UNITED STATES PATENT AND TRADEMARK OFFICE

10/049,597	02/14/2002	Francis Mouyen	0559-0110P	9713
------------	------------	----------------	------------	------

Office Action Summary

DETAILED ACTION***Claim Rejections - 35 USC § 103***

Figure 1 - U.S. Patent 4,995,062 to Schulza-Ganzlin et al.

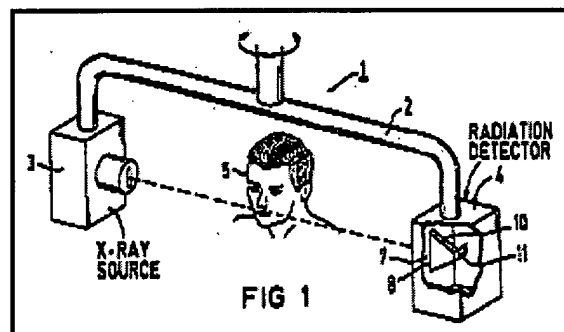
5. As per claim 1, Schulza-Ganzlin et al. disclose a method comprising the steps of emitting a bundle of X-rays in the direction of a tooth and its surrounding area and guiding the X-rays that emerge from the tooth and its surrounding area; transforming X-rays into light rays of a greater wavelength than that of X-rays (Fig. 2, #9; column 3, lines 5-6); converting these light rays into electrical signals and processing these signals to produce radiographic data (abstract). Schulza-Ganzlin et al. do not explicitly disclose the step of guiding emerging X-rays into substantially cylindrical volumes substantially along the axis of the volume.

11. As per claim 3, Schulza-Ganzlin et al. as modified above, disclose a method comprising converting light rays into analogue signals and subsequently into digital electrical signals (Schulza-Ganzlin et al.; Fig. 4-16)

14. As per claim 5, Schulza-Ganzlin et al. as modified above disclose an apparatus comprising a source (Schulza-Ganzlin et al.- 3); a plurality of cylindrical rods (Mouyen - 40) capable of transforming x-rays into light rays of wavelengths greater than x-rays; means (Schulza-Ganzlin et al.- 11) for converting light rays into electrical signals; means (Schulza-Ganzlin et al.- 10) for connecting cylindrical rods to means (11) and means for processing electrical signals (Schulza-Ganzlin et al.-16, 17, 18, 29, 20, 21).

Figure 4 - U.S. Patent 4,995,062 to Schulza-Ganzlin et al.

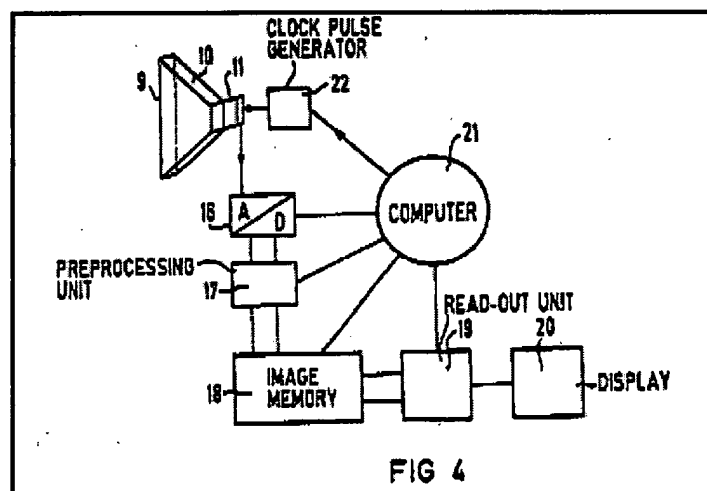
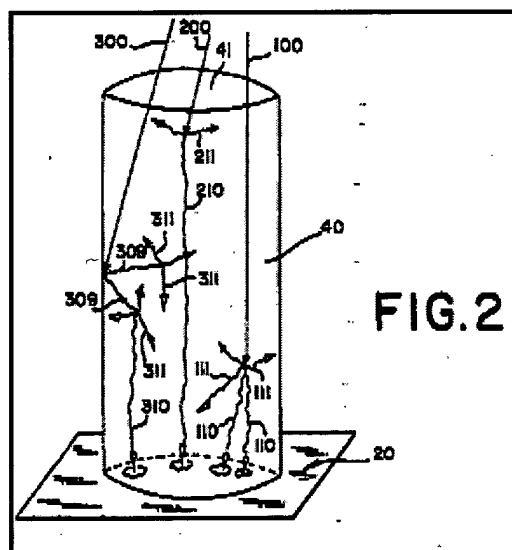
15. As per claim 6, Schulza-Ganzlin et al. as modified above disclose an apparatus configured to convert light rays into analogue signals and a converter for converting analogue signals into digital signals (see Schulza-Ganzlin et al.; Fig. 4-16).

16. As per claim 7, Schulza-Ganzlin et al. as modified above disclose an apparatus comprising a CCD bar (see Schulza-Ganzlin et al.; Fig. 4-11) for converting light rays into analogue signals. Schulza-Ganzlin et al. do not explicitly disclose an apparatus comprising a CAN converter for converting analogue signals into digital signals.

17. Schulza-Ganzlin et al. teach the use of a converter (16) for converting analogue signals to digital signals.

Figures 1 and 2 - U.S. Patent 5,382,798 to Mouyen

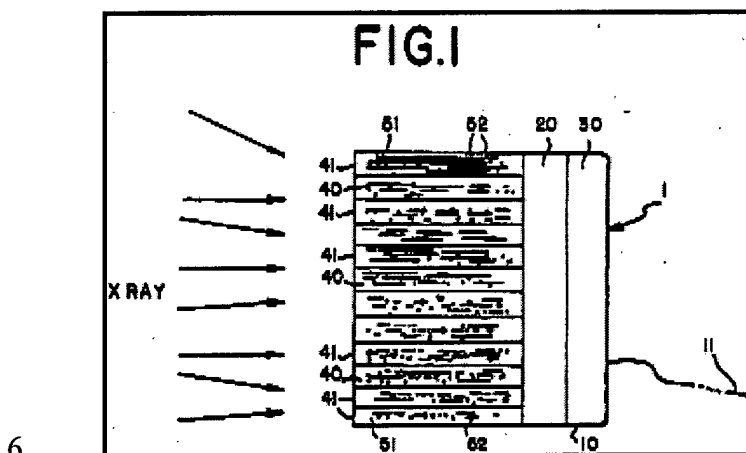
7. Mouyen discloses a method comprising the step of guiding emerging X-rays (200) into substantially cylindrical volumes (40) substantially along the axis of the volume. Mouyen teaches that guiding emerging X-rays results in the formation of high quality pictures (column 1, lines 36-41).

8. It would have been obvious to modify the method of Schulza-Ganzlin et al. such that it incorporated the step of guiding emerging X-rays into substantially cylindrical volumes substantially along the axis of the volume. One would have been motivated to make such a modification so that received radiation is used to form high quality pictures, by reducing diffuse radiation as taught by Mouyen (column 1, lines 36-41; column 3, lines 51-63).
